ADDENDUM NO. 2

01-11-2024

Porterville College Sports Complex (PC Baseball/ Softball Field)
100 E College Ave,
Porterville, CA 93257

DARDEN PROJECT NO. 2118
DSA File Nos. 03-122694
DSA APPL. NO. 15-C1

SD/C301
AD2-CX01

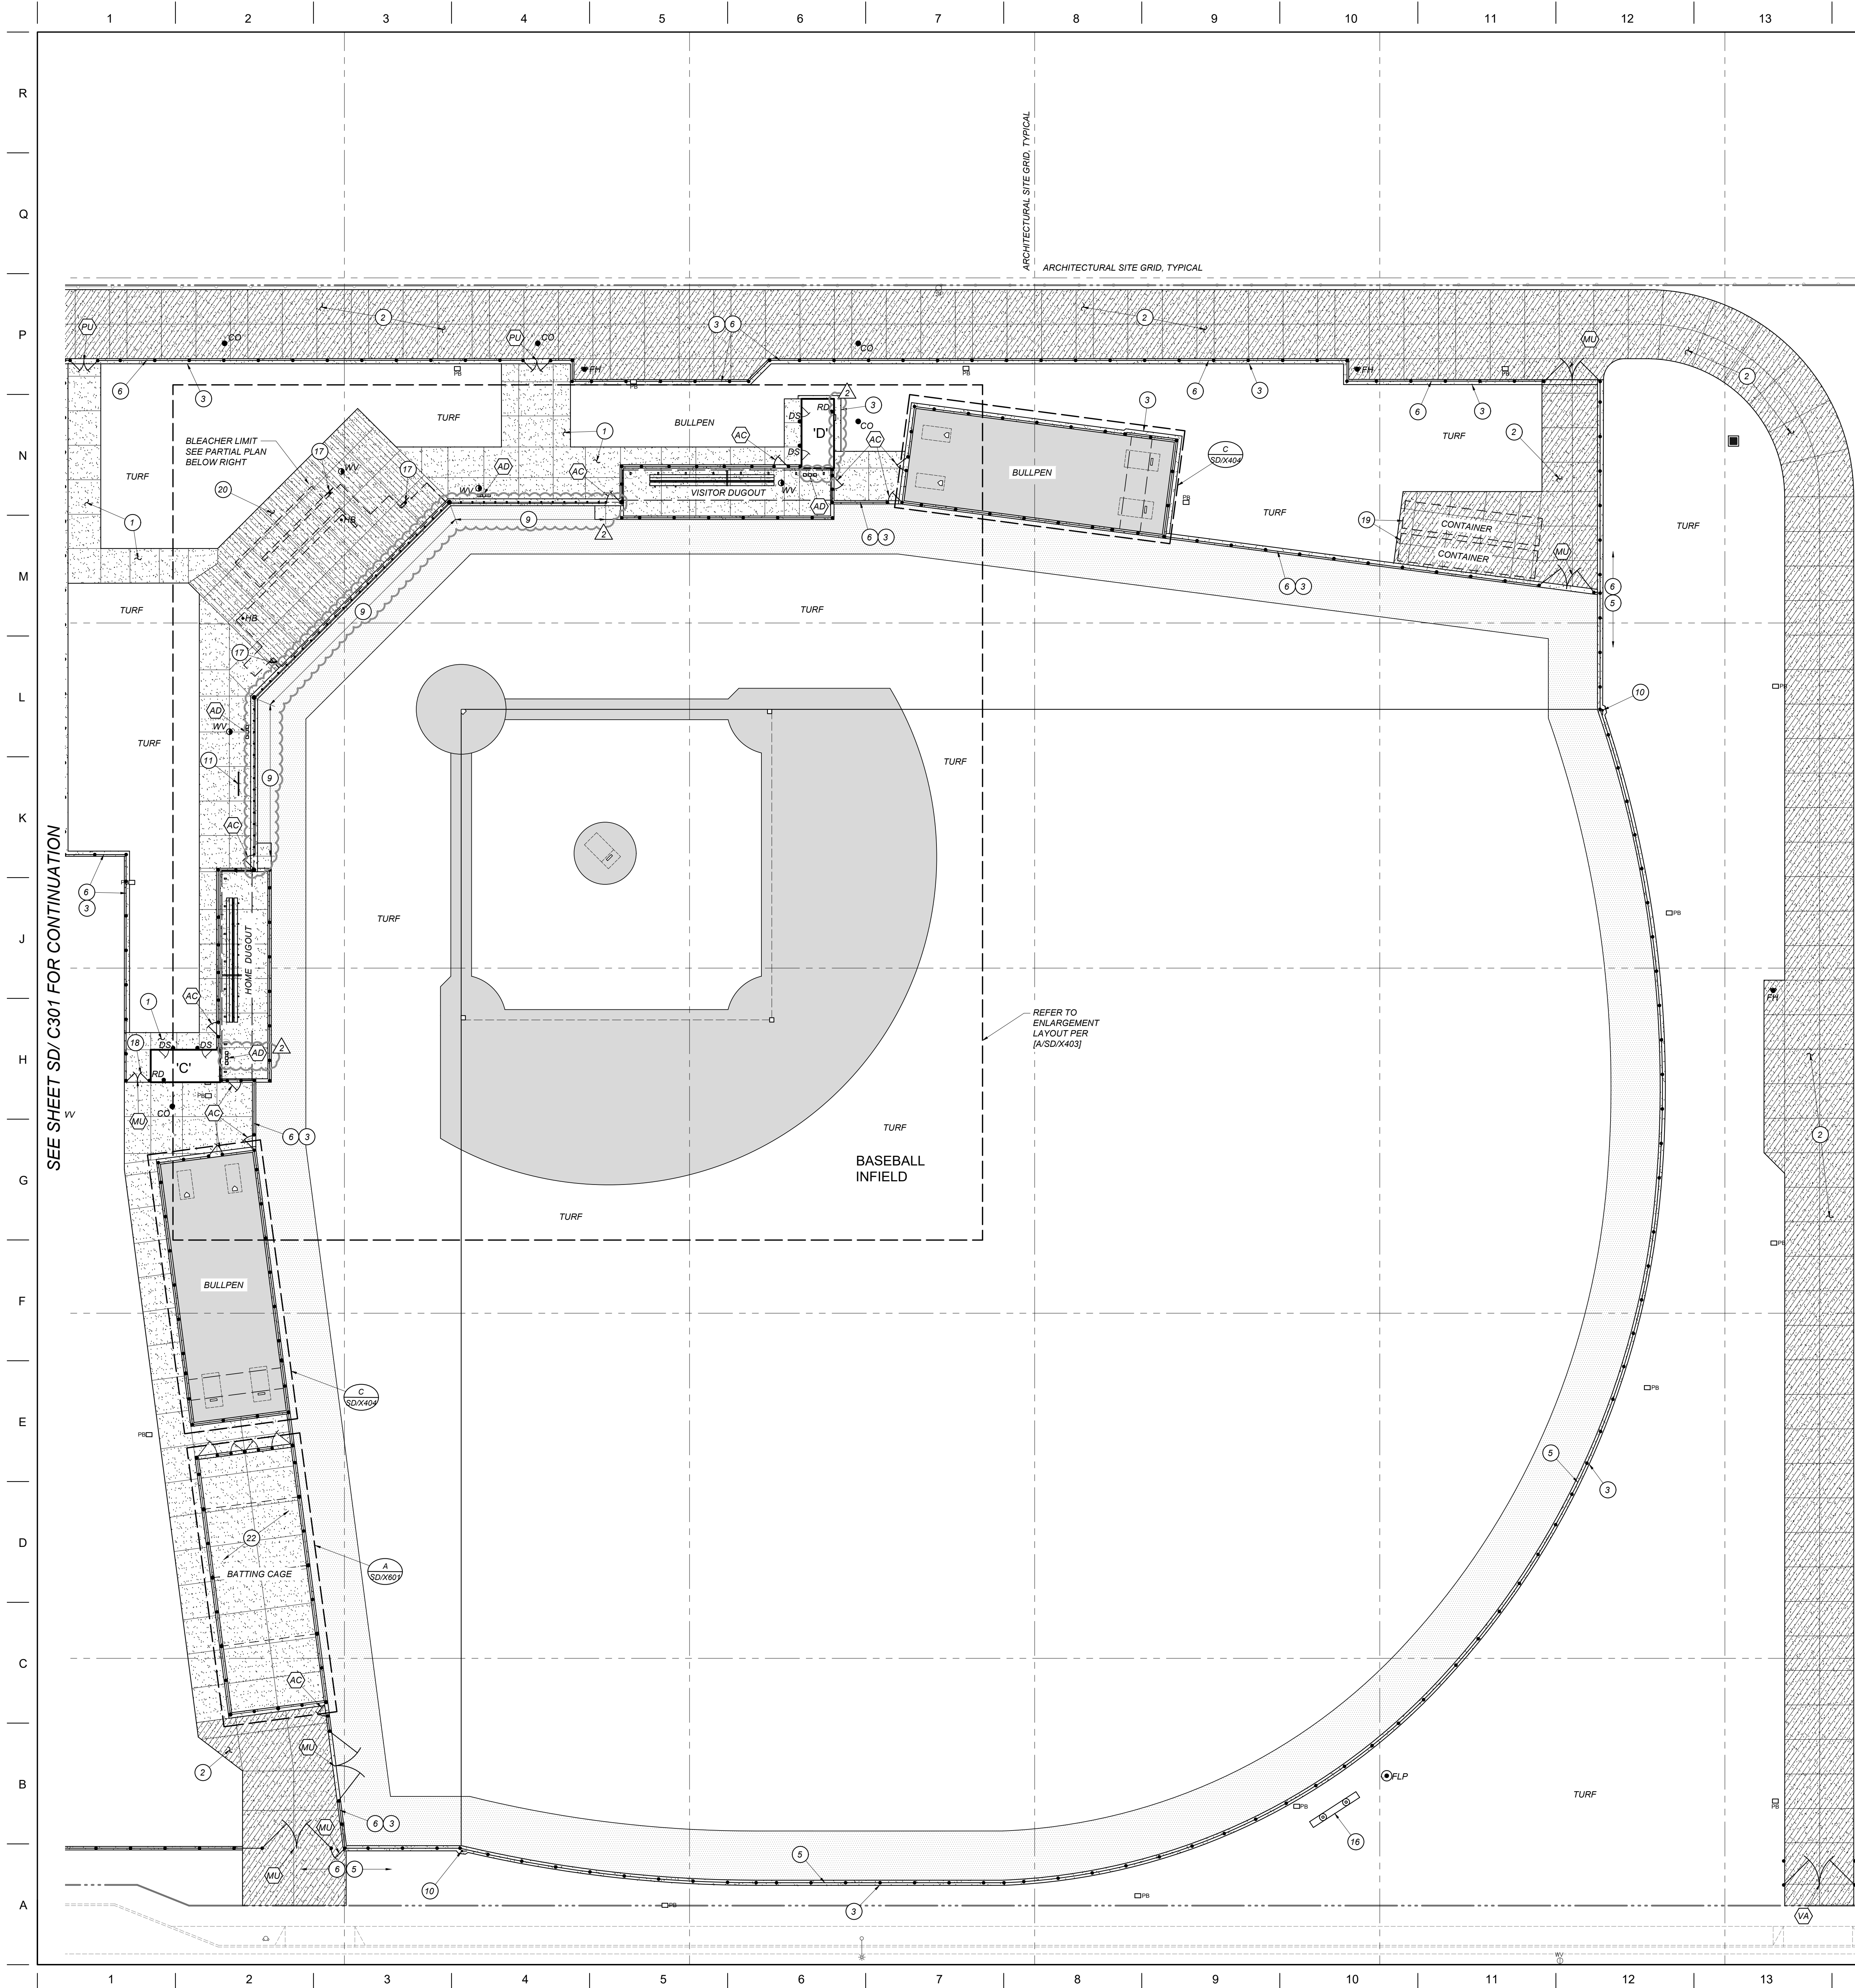
- AD2-C01 Refer to Sheet SD/C301 and attached Sheet AD2-CX01**
1. Replace Sheet SD/C301 with the attached Sheet AD2-CX01
 2. Refer to clouded changes on Sheet AD2-CX01

SD/X202 AD2-CX11

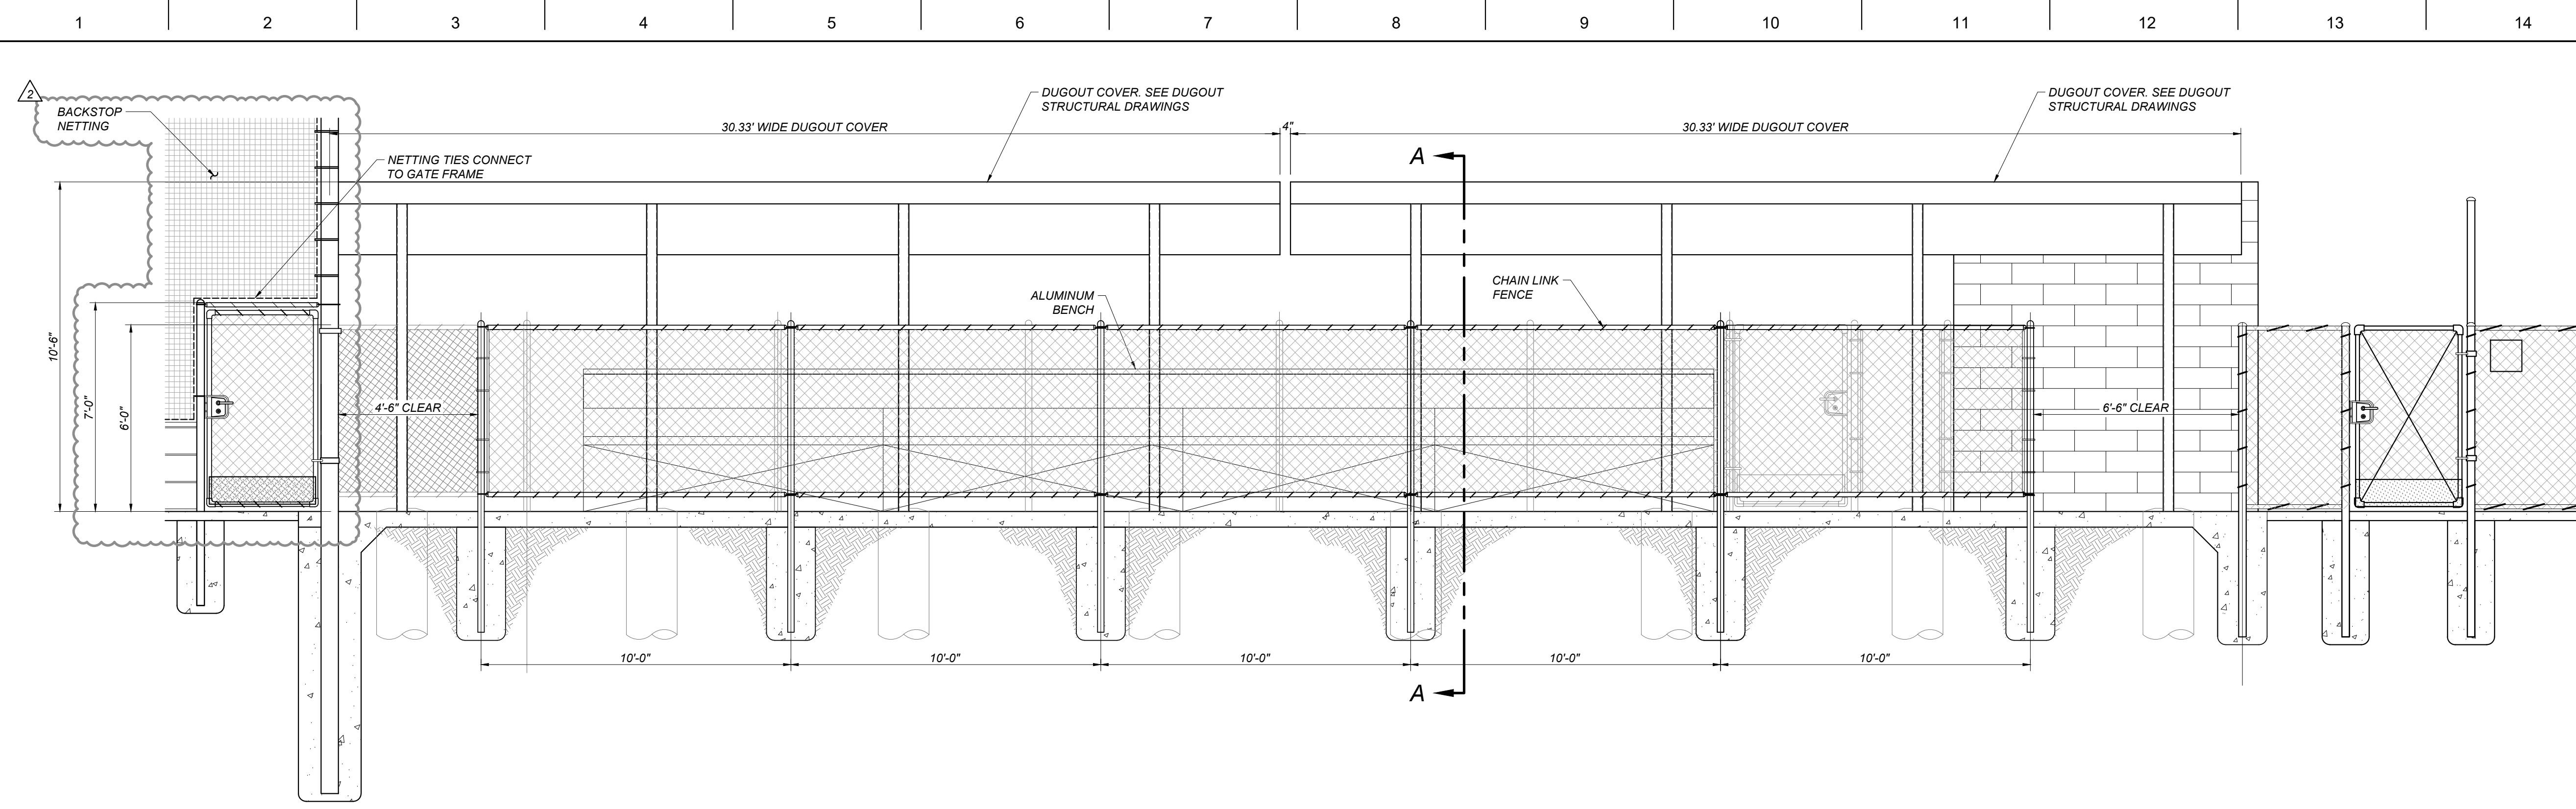
- AD2-C11 Refer to Sheet SD/X202 and attached Sheet AD2-CX11**
 - 1. Replace Sheet SD/X202 with the attached Sheet AD2-CX11
 - 2. Refer to clouded changes on Sheet AD2-CX11

SD/X402
AD2-CX13

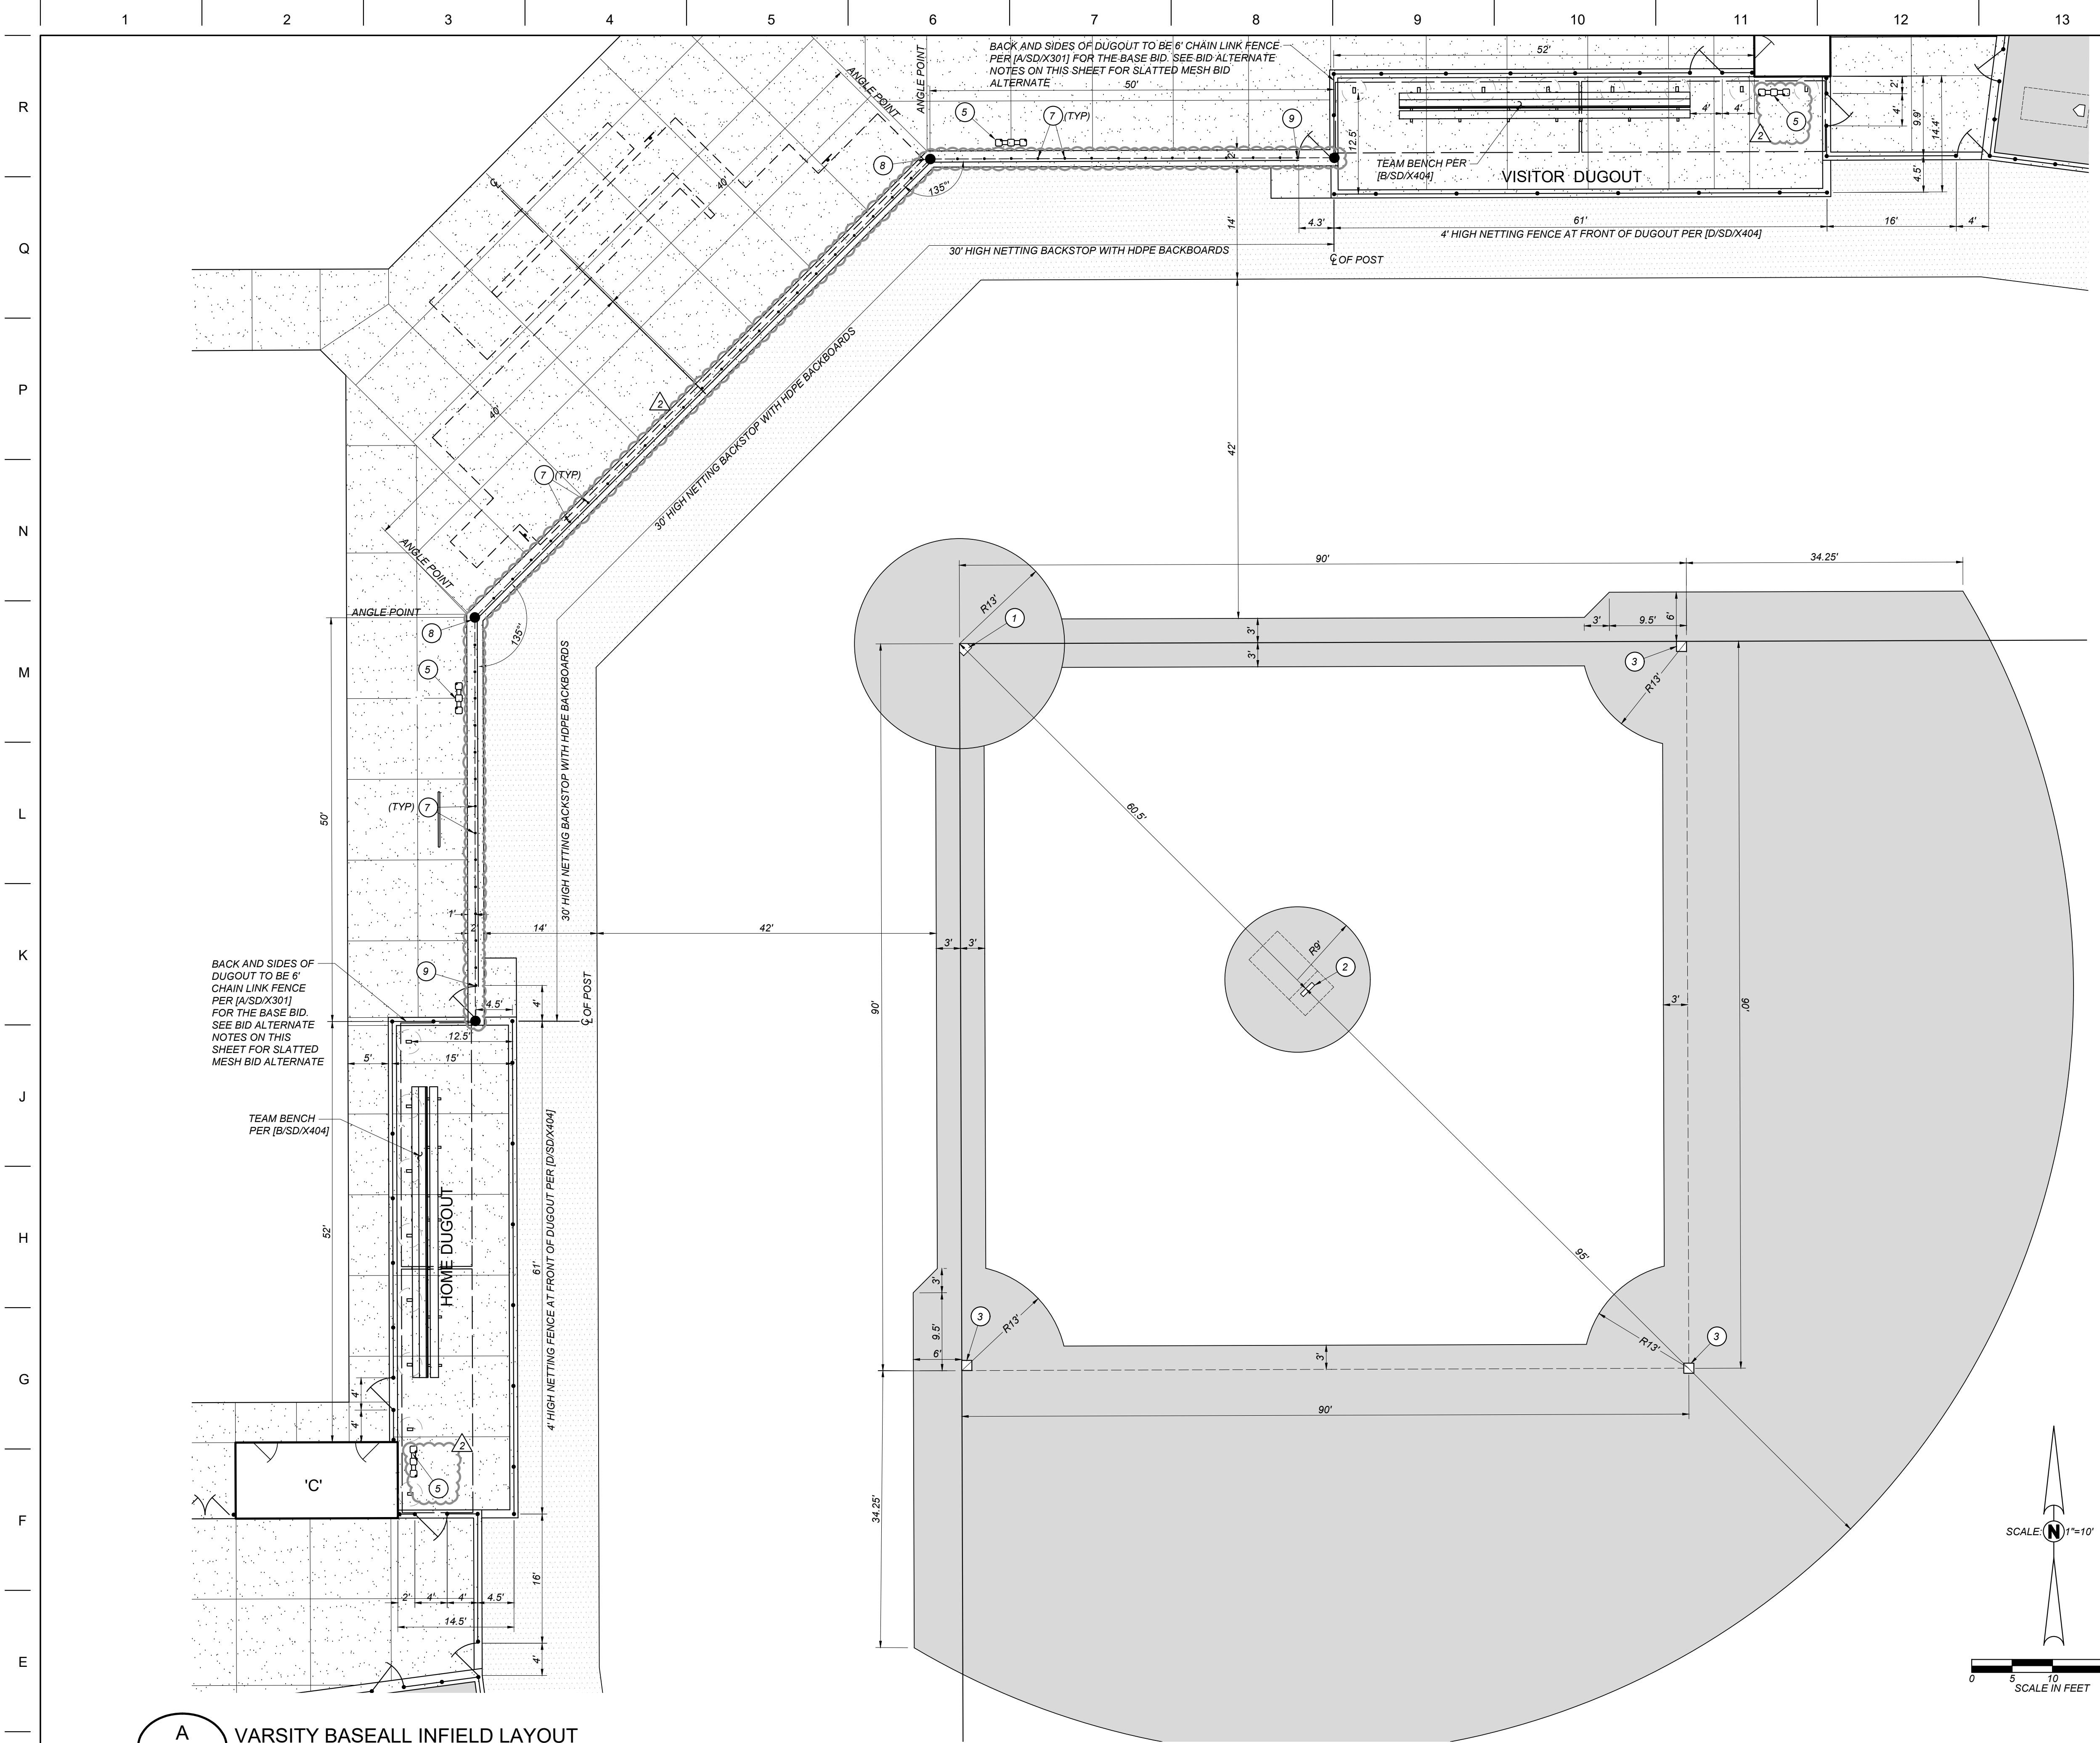
- AD2-C13 Refer to Sheet SD/X402 and attached Sheet AD2-CX13**
 - 1. Replace Sheet SD/X402 with the attached Sheet AD2-CX13
 - 2. Refer to clouded changes on Sheet AD2-CX13
